**2021 CMOM PACKAGE 2A (CIPP)
Solicitation Number: CO-00684
Job No.: 23-4513**

**ADDENDUM 1
January 31, 2024**

2021 CMOM
 PACKAGE 2A (CIPP)
 WORKSITE 1
 JACKSON KELLER ROAD
 CIPP

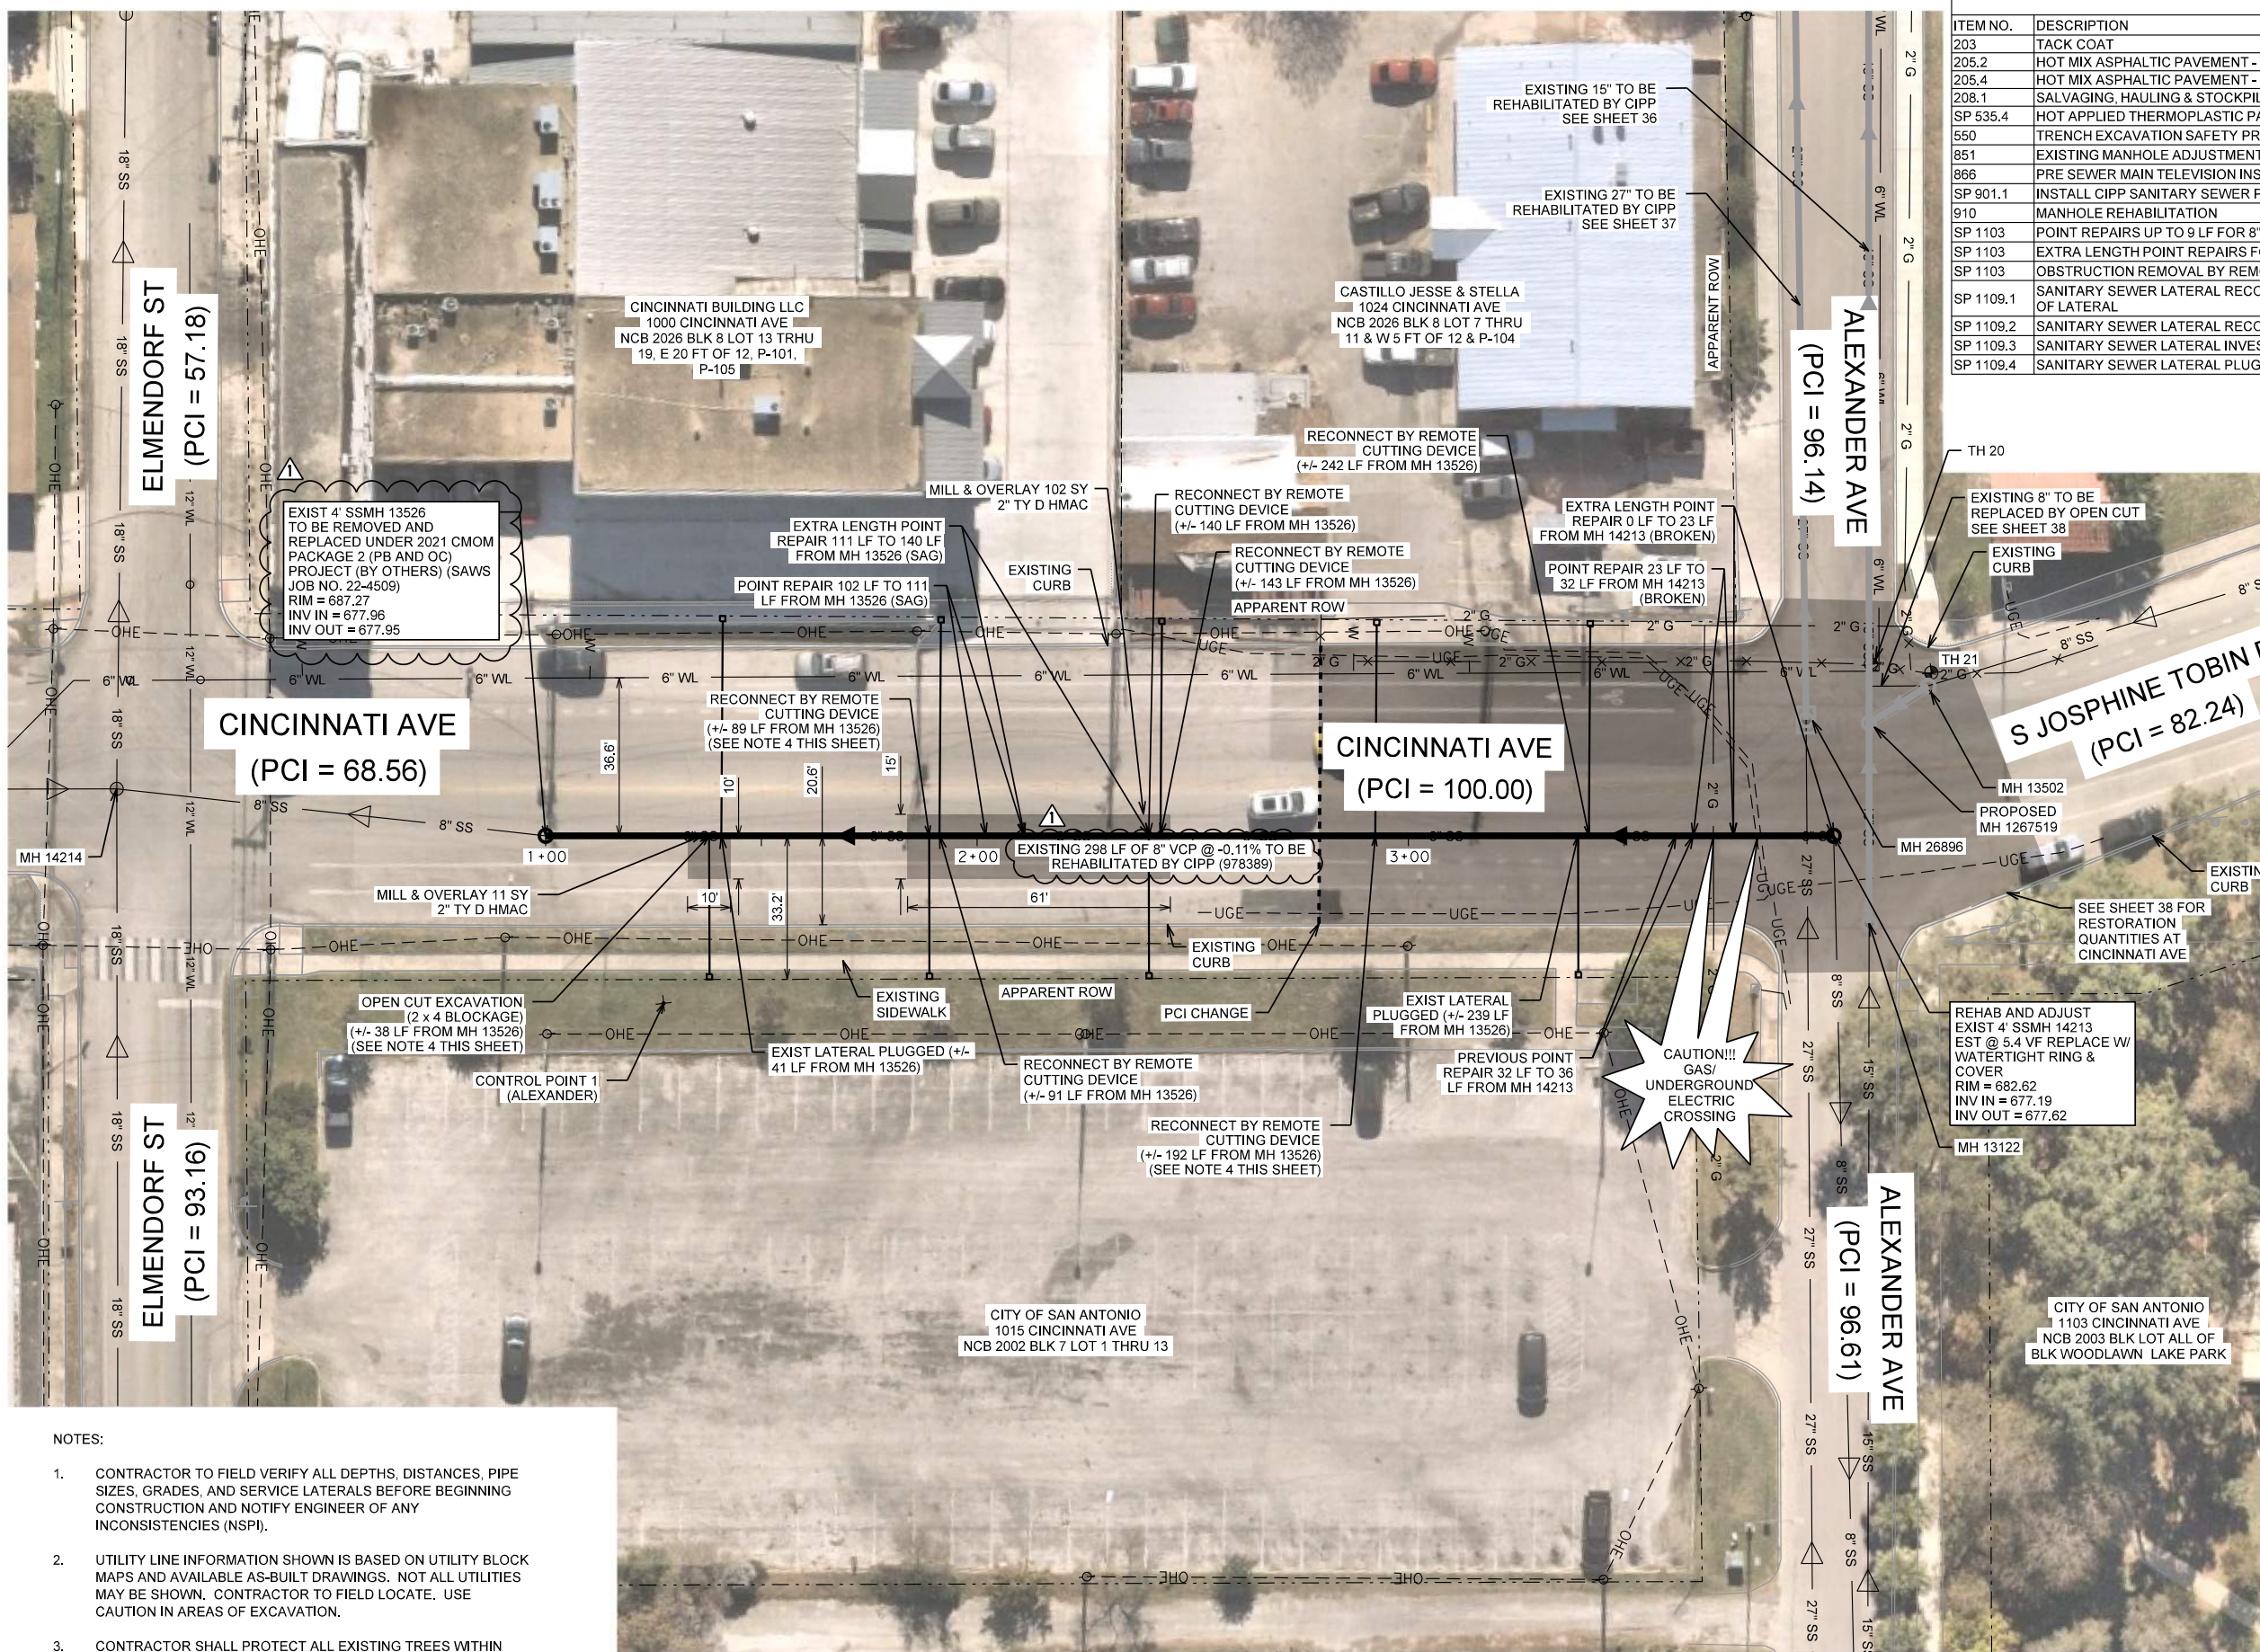
4. Can you provide the Rim & Invert elevations for MH 7246 & 13526 so that the CIPP designs can be calculated?

1. Sheet 10 – Replace plan sheet 10 dated 1/5/2024 with attached sheet 10 dated 1/24/2024.
2. Sheet 39 – Replace plan sheet 39 dated 1/5/2024 with attached sheet 10 dated 1/26/2024.

Response: Revised plan sheets 10 and 39 are attached to this Addendum. Please see Changes to The Plans Numbers 1 and 2.
